Access Compliance Report Public Rights-of-Way (Curb Ramps)

Main Street: MARTHA_ANN_DR		Cross Street: COPA_DE_ORO_DR		Location:	NE
ADA ID: RPRK211207121720	Ramp Type: Type 4 - Parallel	Initial Pass/Fail: Fail	Overall Compliance: No	Severity Score:	15
Codes/Mitigation Info/Possible Solution			Field Measurements/Component Compliance

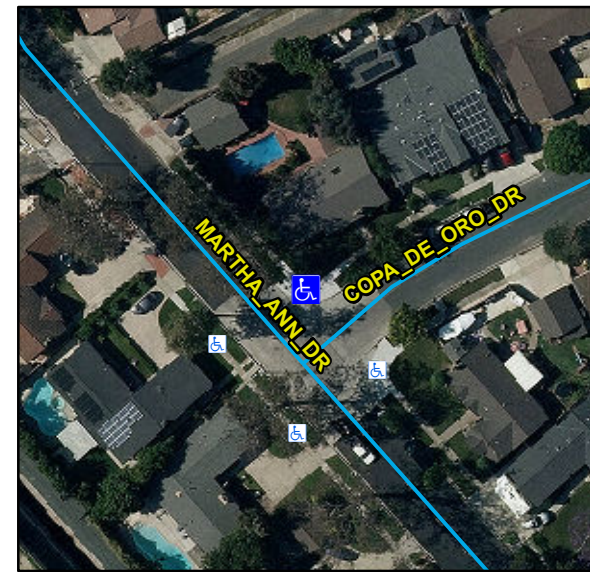
Compliance	Description	Data	Compliance	Description	Data
N/A	Ramp Length LT (in)	87	N/A	Ramp Length RT (in)	86
Yes	Ramp Width LT (in)	83	Yes	Ramp Width RT (in)	83
Yes	Ramp Run Slope LT (%)	4.8	Yes	Ramp Run Slope RT (%)	2.5
No	Ramp Cross Slope LT (%)	2.3	No	Ramp Cross Slope RT (%)	6.7
N/A	Landing Present	N/A	N/A	DWS Provided	N/A
N/A	Landing Length (in)	N/A	N/A	DWS Contrast	N/A
N/A	Landing Width (in)	N/A	N/A	DWS Length (in)	N/A
N/A	Landing Run Slope (%)	N/A	N/A	DWS Full Width	N/A
N/A	Landing Cross Slope (%)	N/A		DWS Offset Type	N/A
N/A	Landing Movement Obstructed?	N/A	N/A	DWS Offset Left (in)	N/A
	Landing Movement Type	N/A	N/A	DWS Offset Right (in)	N/A
N/A	Landing Shared	N/A			
N/A	Clear Space	Yes			
N/A	Clear Space To Crosswalk (in)	N/A			
N/A	Marked Crosswalk 1	No	N/A	Marked Crosswalk 2	No
	Crossing 1 Direction	W		Crossing 2 Direction	S
N/A	Marked Crosswalk 1 Width (in)	N/A		Marked Crosswalk 2 Width (in)	N/A

Remove & Replace Curb Ramp With Two New Directional Ramps or Equivalent.

R304.5.3, STD 1115
